Re: Florida Power & Light Company  
Proposed Turkey Point Units 6 and 7  
Docket Nos. 52-040 and 52-041  
Voluntary Revised Response to NRC Request for Additional Information Letter No. 041 (eRAI 6024) SRP Section: 02.05.01 - Basic Geologic and Seismic Information

Attachment: FPL Revised Response to NRC RAI No. 02.05.01-15 (eRAI 6024)

**NRC RAI Number: 02.05.01-15 (eRAI 6024)**

Figure 1. (A) Time section of Santaren Anticline from Ball et al. (1985) (FSAR Reference 2.5.1-501, Figure 9). (B) Migrated depth section of profile from (A) with 2x vertical exaggeration. Ball et al. (1985) (FSAR Reference 2.5.1-501) propose a fault as dashed.

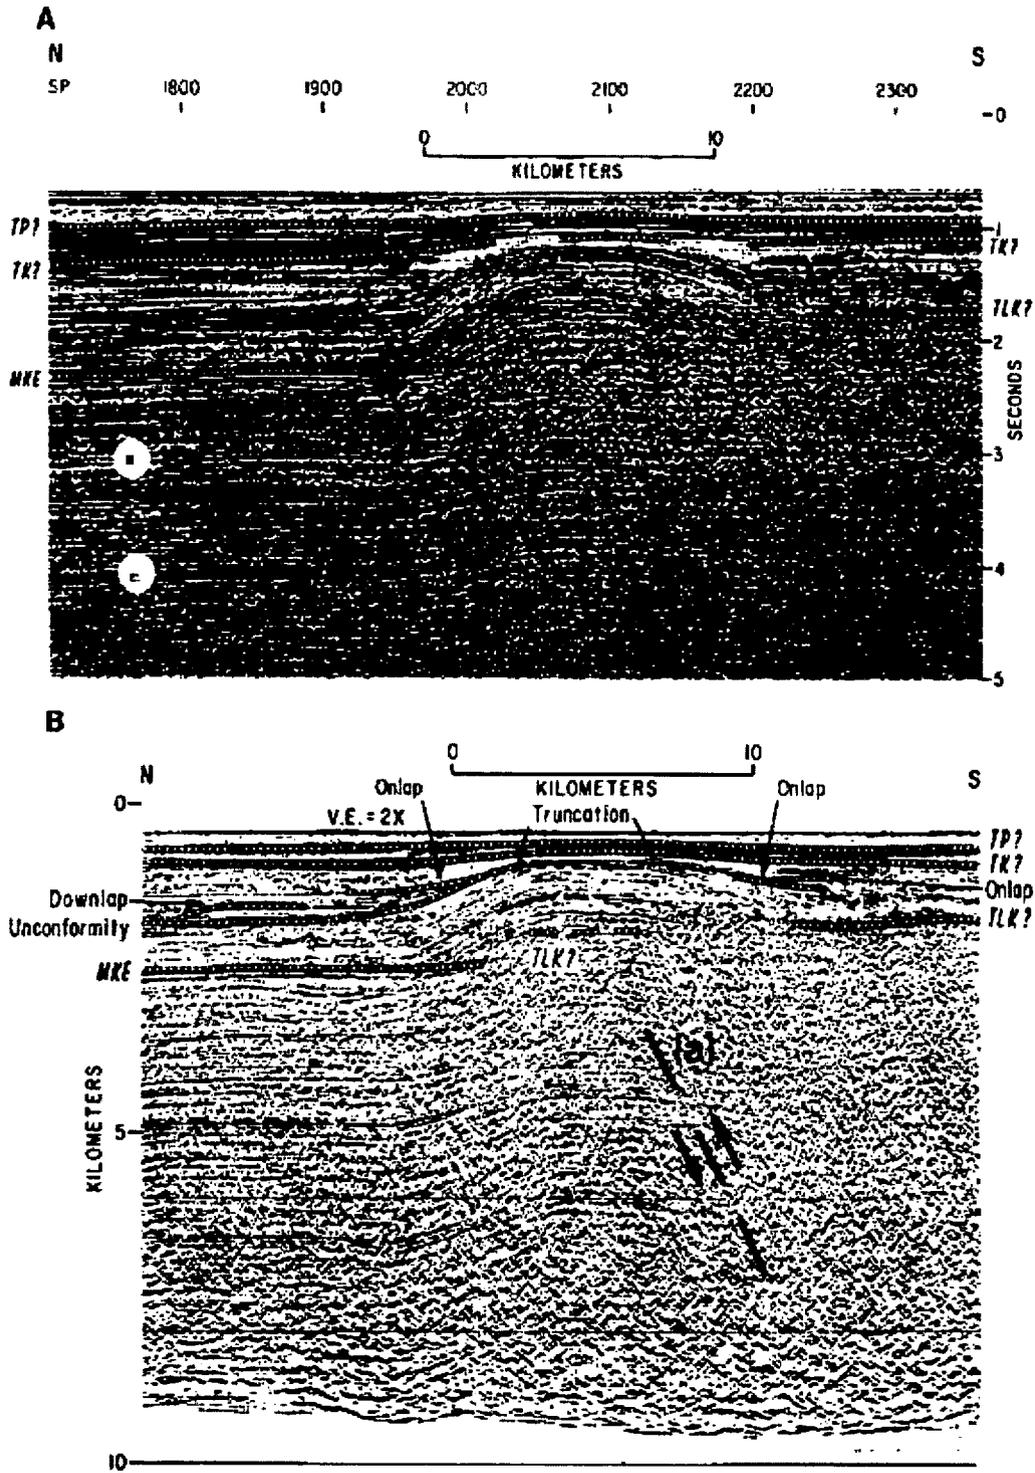
Ball et al. (1985) (FSAR Reference 2.5.1-501, pp. 1,290-1,292) also provide a structural interpretation of the Santaren anticline in their Figure 9b (Figure 1), noting “Deep terminations occur, below 4 km depth, in inferred basinal sediments beneath the anticline, 3 km north of the zone of dip and thickness variation. Some major dislocation related to faults may have caused the aberrant dips and local thickness variations. However, the regional thinning was caused by southward onlap of basinal carbonates on shallow-water carbonate material. Subsequent compressional tectonism produced the anticline.” Based on the previously quoted age determinations, the location of the anticline, the interpreted asymmetry of the anticline, and the interpretation of a fault below 4 km depth, Ball et al. (1985) (FSAR Reference 2.5.1-501, p. 1,294) state “We speculate that this structure is a hanging-wall anticline marking the northern limit of thrusting in the Cuban arc.”

Ball et al. (1985) (FSAR Reference 2.5.1-501) do not calculate shortening rates for the Santaren anticline. Furthermore, it should be noted that the location of the steeply dipping fault dashed in Ball et al.'s (1985) (FSAR Reference 2.5.1-501) Figure 9b (Figure 1) is kinematically incompatible with the location of the Santaren anticline. As drawn, at least half of the interpreted hanging-wall anticline is actually on the footwall of the dashed fault.

These data and interpretations are not used by Ball et al. (1985) (FSAR Reference 2.5.1-501) to provide evidence of ongoing deformation or to calculate present day rates of shortening across the Santaren anticline. Ball et al. (1985) (FSAR Reference 2.5.1-501, p. 1287) specifically note that “late Cenozoic expression” (which presumably refers to the interpretation of thinned Paleogene strata, the youngest strata that are discussed) may not be related to tectonic processes, but may instead be the result of differential compaction.

Figure 3. Seismicity in the Vicinity of the Santaren Anticline.

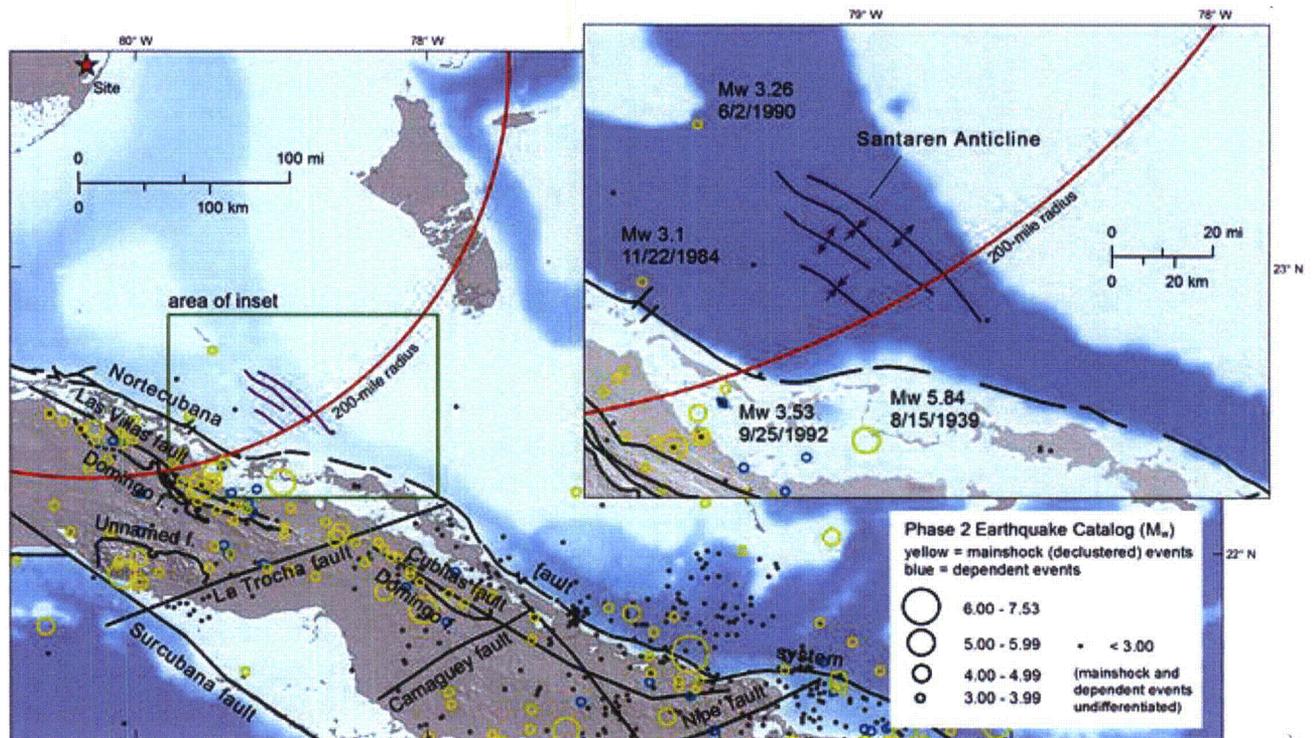
**b) Plot regional seismicity on a close-up view of the Santaren Anticline and comment whether the Santaren Anticline is a capable tectonic structure.**

The Santaren anticline and three unnamed fold axes directly to its southwest from Masafarro et al. (1999) (FSAR Reference 2.5.1-426) are shown on Figure 3, along with earthquake epicenters from the Phase 2 earthquake catalog. Earthquake activity is very sparse in the vicinity of the Santaren anticline, and there does not appear to be a spatial association between seismicity and the Santaren anticline or with the unnamed fold axes directly to the southwest (Figure 3).

Regardless of these structural interpretations, the issue of whether or not the Santaren anticline is a capable tectonic structure is addressed by data presented by Masferro et al. (2002) (FSAR Reference 2.5.1-479). The calculated fold uplift rates for the Santaren anticline, as depicted in Figure 4c of FSAR Reference 2.5.1-479 (Figure 2), show no uplift since deposition of beds M2-M3. As detailed in part (a) of this response, this period of tectonic quiescence spans the period from approximately 1 Ma to present. The fact that FSAR Reference 2.5.1-479 depicts no uplift in the most recent 1 million years would therefore support the conclusion that the Santaren anticline does not represent a capable tectonic structure. The sparse seismicity near this structure further supports this argument (Figure 3).

The Associated COLA Revisions previously submitted to the NRC in Attachment 15 to FPL Letter L-2014-281, Pages 10 to 11, were incorporated in Revision 5 of the COLA. A new revision to FSAR Figure 2.5.1-350 (Figure 3 in this response) will be provided in the response to RAI 02.05.01-34 for incorporation into a future COLA revision.
